World Forum for Harmonization of Vehicle Regulations**Working Party on Passive Safety****Seventy-third session**

Item 13 of the provisional agenda

UN Regulation No. 134 (Hydrogen and Fuel cell vehicles)**Proposal for the 02 Series of Amendments to UN Regulation No. 134 – Consolidated Text on the Safety-Related Performance of Hydrogen-Fuelled Vehicles *****Submitted by the task force amending UN Regulation No.134**

Figure 12
Verification Test for Performance Durability (Hydraulic)

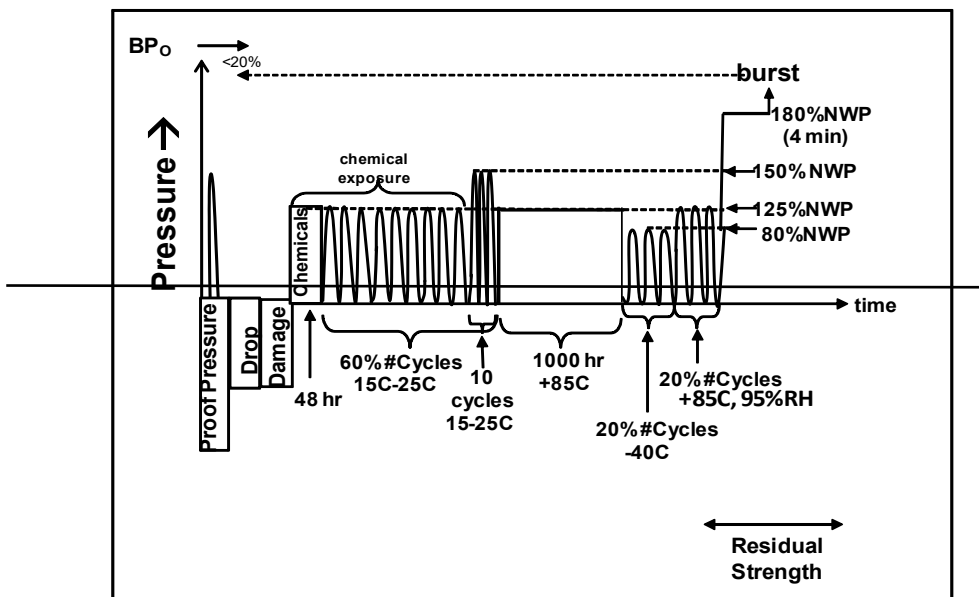
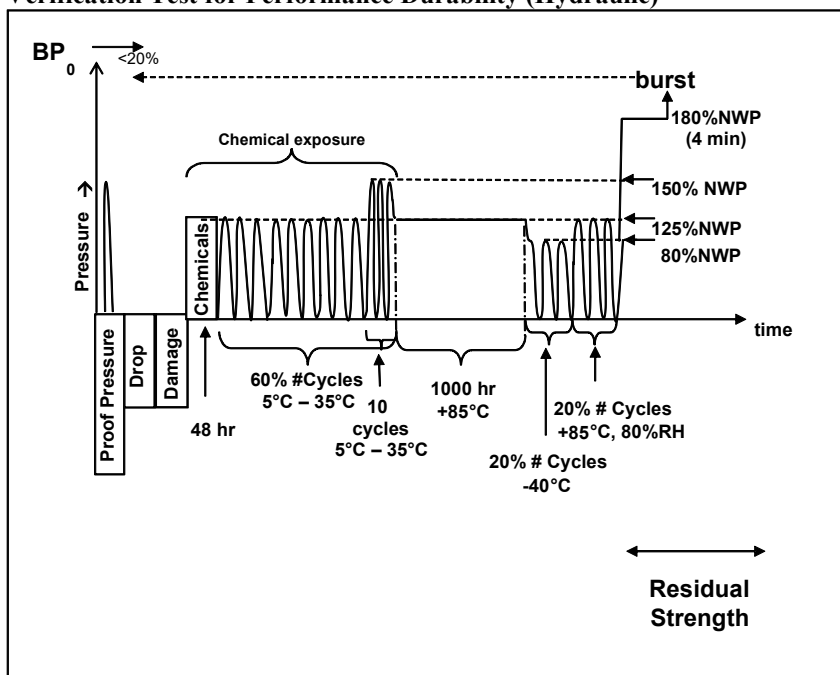
Unless otherwise specified, the tests in paragraph 5.2 shall be conducted on the container equipped with its container attachments (if any) [as well as supply lines for additional TPRDs (if any) through appropriate adaptors] that represents the CHSS without the primary closures.

~~A hydrogen storage~~ **The container shall not leak during the following sequence of tests, which are applied in series to a single system and which are illustrated**

Figure 23
Verification Test for Expected On-Road Performance (Pneumatic/hydraulic)

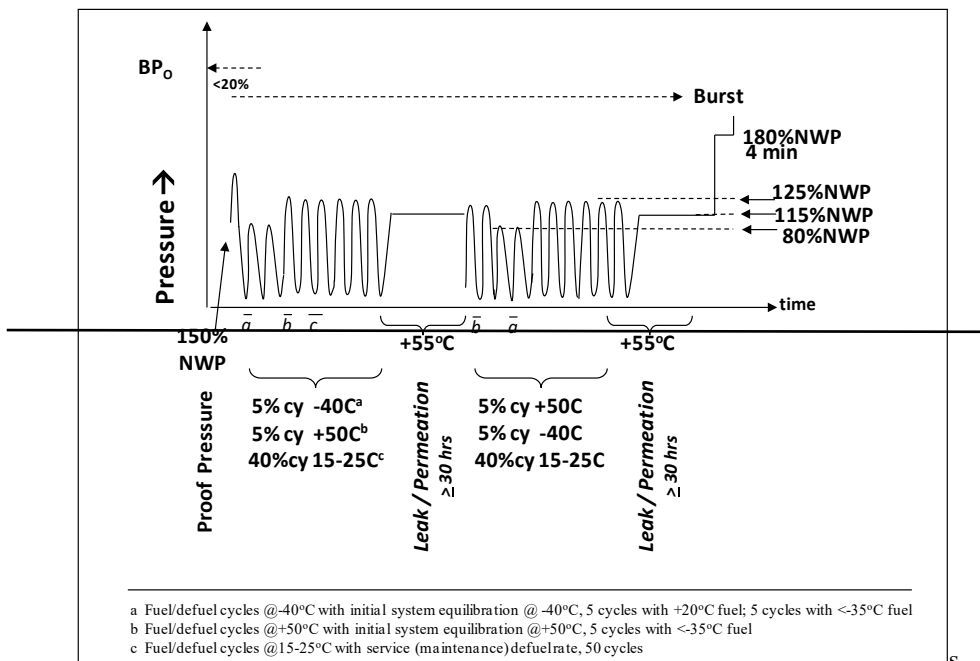
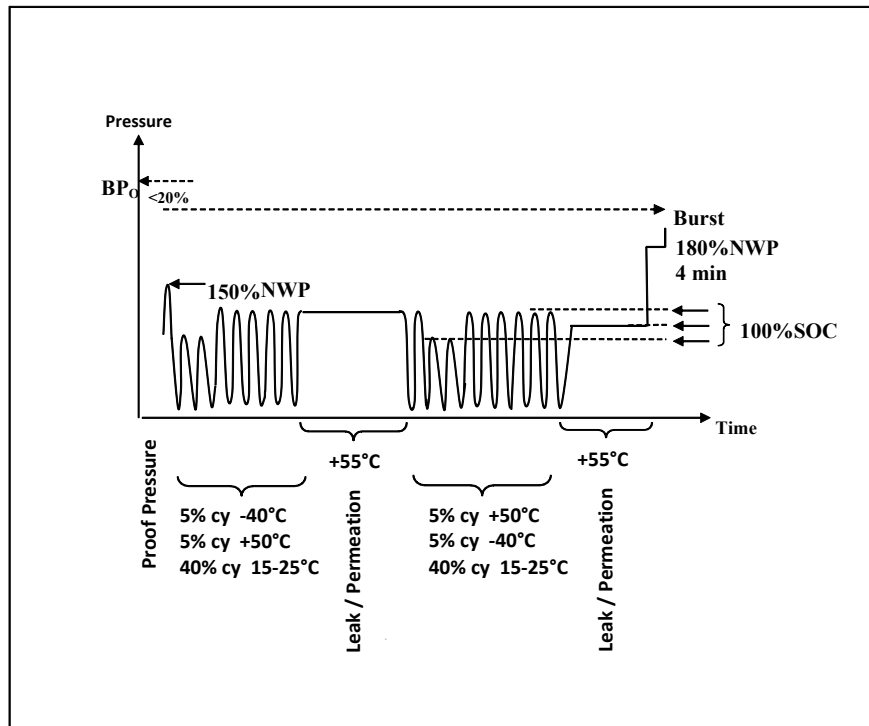
- 5.3. Verification test for expected on-road performance (Pneumatic sequential tests)
- ~~A hydrogen storage system~~ CHSS shall **undergo not leak** during the following sequence of tests, which are illustrated in Figure 23. Specifics of applicable test procedures for the ~~CHSS hydrogen storage system~~ are provided in Annex 3.

- The CHSS shall not leak and the primary closure devices shall maintain functionality during the test.**

Figure 1
Drop Orientations

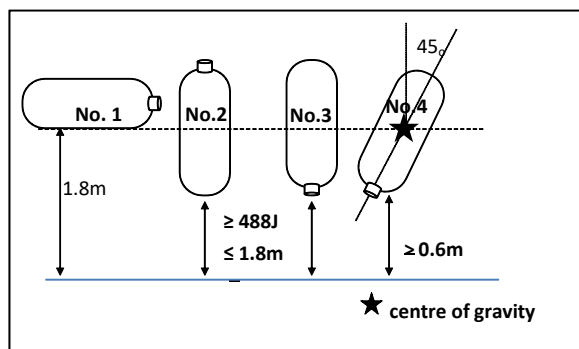
- (iv) ~~Dropped once at~~ From a 45° angle from the vertical orientation with the **shut-off valve interface location** ~~a ported end~~ downward with its centre of gravity ≤ 1.8 m above the ground. However, if the bottom is closer to the ground than 0.6 m, the drop angle shall be changed to maintain a minimum height of 0.6 m and a centre of gravity of ≤ 1.8 m above the ground. **In case of a non-axisymmetric container, the line passing the shut-off valve interface location end and its centre of gravity shall be 45° angled from vertical orientation and the shut-off valve interface location shall become the lowest.**

The four drop orientations are illustrated in Figure 1.

Figure 2
Surface Damage Flow Chart

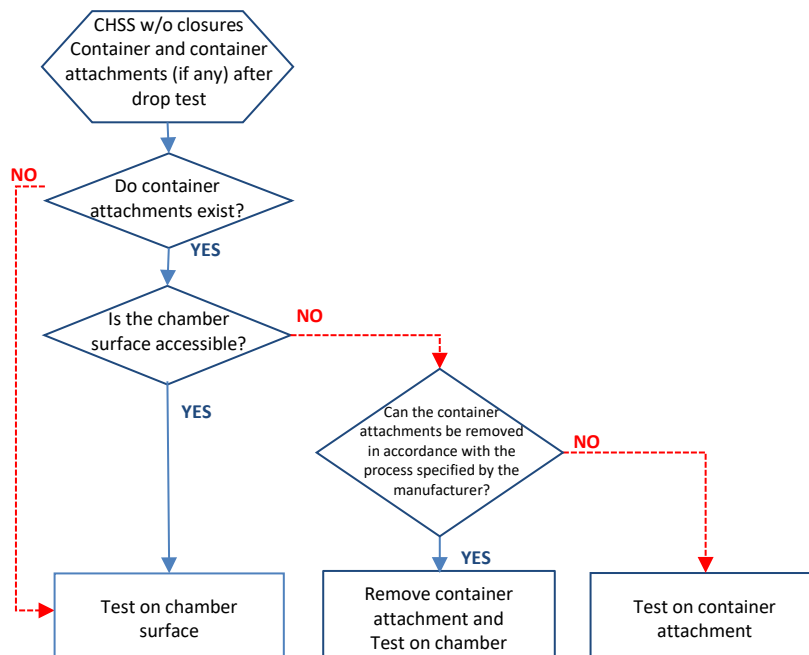
If the container attachments can be removed in accordance with the process specified by the manufacturer, then the container attachments shall be removed, and the tests shall be conducted on the surface of the pressure bearing chamber of the container.

Otherwise, the tests shall be conducted on the surface of the container attachments as indicated in Figure 2.

Figure 32
Side View of the Container

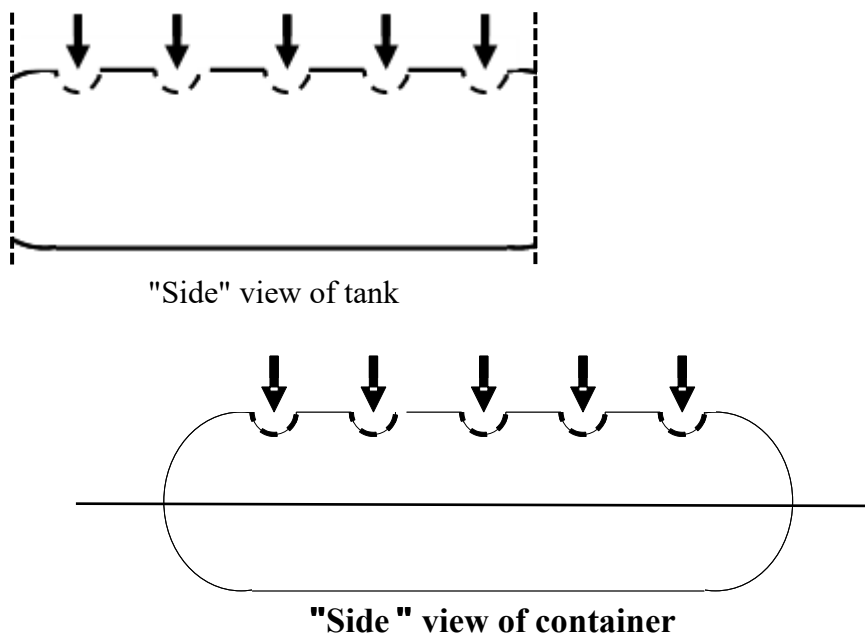
If the container is to be affixed to the vehicle by compressing its composite surface, then a second cut at least 1.25 mm deep and 25 mm long is applied at the end of the container which is opposite to the location of the first cut; Two longitudinal saw cuts are made on the bottom outer surface of the unpressurized horizontal storage container along the cylindrical zone close to but not in the shoulder area. The first cut is at least 1.25 mm deep and 25 mm long toward the valve end of the container. The second cut is at least 0.75 mm deep and 200 mm long toward the end of the container opposite the valve;

- (b) Pendulum impacts: **A surface of the test article opposite to the surface specified above or a surface of a different chamber, in the case of a container with multiple permanently interconnected chambers, The upper section of the horizontal storage container is divided into five distinct (not overlapping) areas 100 mm in diameter each (see Figure 32). After Immediately following a minimum of 12 hours preconditioning at ≤ -40 °C in an environmental chamber, the centre of each of the five areas sustains the impact of a pendulum having a pyramid with equilateral faces and square base, the summit and edges being rounded to a radius of 3 mm. The centre of impact of the pendulum coincides with the centre of gravity of the pyramid. The energy of the pendulum at the moment of impact with each of the five marked areas on the container is ≥ 30 J. The container test article is secured in place during pendulum impacts and not under pressure.**
